### Addendum 50: Regulation No. 51

#### Revision ~~23~~

**Uniform provisions concerning the approval of motor vehicles having at least four wheels with regard to their ~~noise-sound~~ emissions**

Model A  
(See paragraph 5.4. of this Regulation)

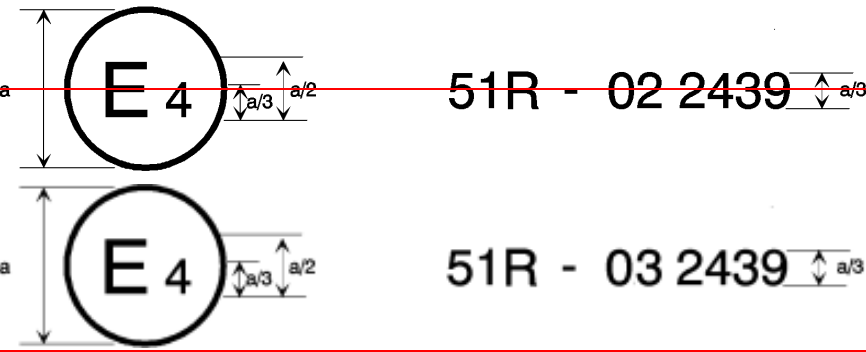
The above approval mark affixed to a vehicle shows that the vehicle type concerned has, with regard to its noise emission, been approved in the Netherlands (E 4) pursuant to UN Regulation No. 51 under approval No. 032439.

The first two digits of the approval number indicate that UN Regulation No. 51 already included the 032 series of amendments when the approval was granted.

Figure 1

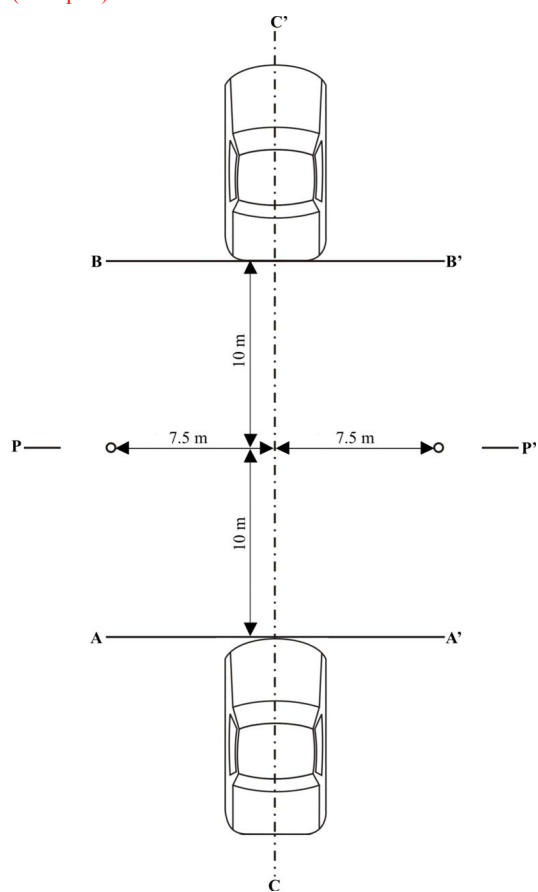
Measuring positions for ~~stationary~~ vehicles in motion  
(examples)

Figure 3a

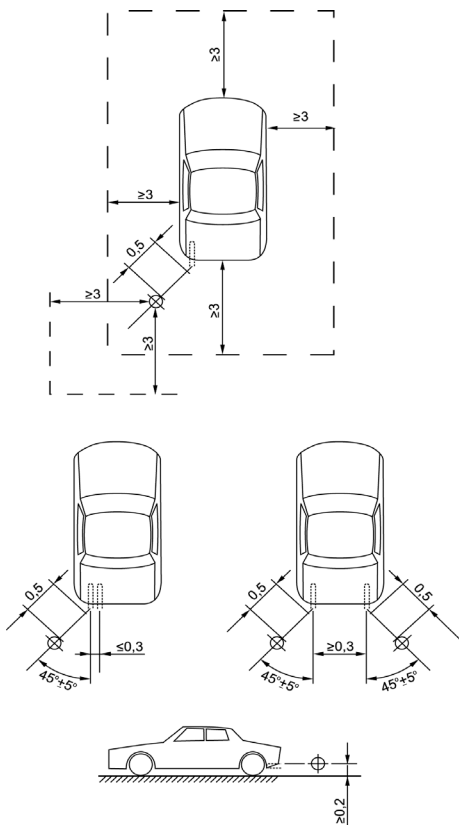
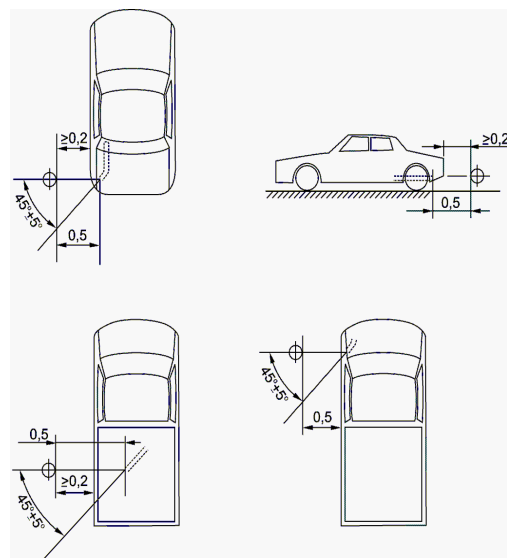
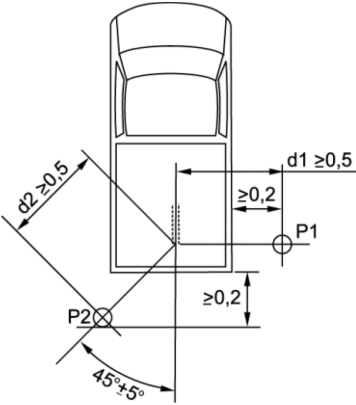
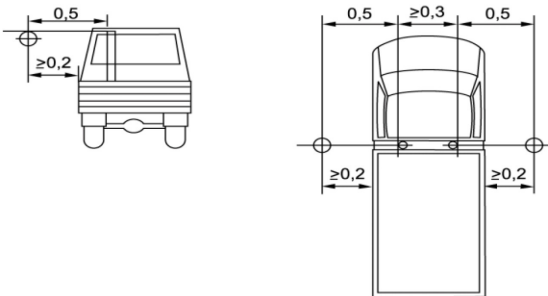
~~When several positions are possible, as shown in Figure 3c, the microphone position giving the lowest value of d1 or d2 shall be used. For exhaust outlets located under the vehicle body, the microphone shall be located a minimum of 0.2 m from the nearest part of the vehicle, at a point closest to, but never less than 0.5 m from the exhaust pipe reference point, and at a height of 0.2 m above the ground, and not in line with the exhaust flow. The angularity requirement in paragraph 3.2.5.3.1.2 may not be met in some cases.~~

~~Note: Figures 3a to 3d show examples of the position of the microphone, depending on the location of the exhaust pipe.~~
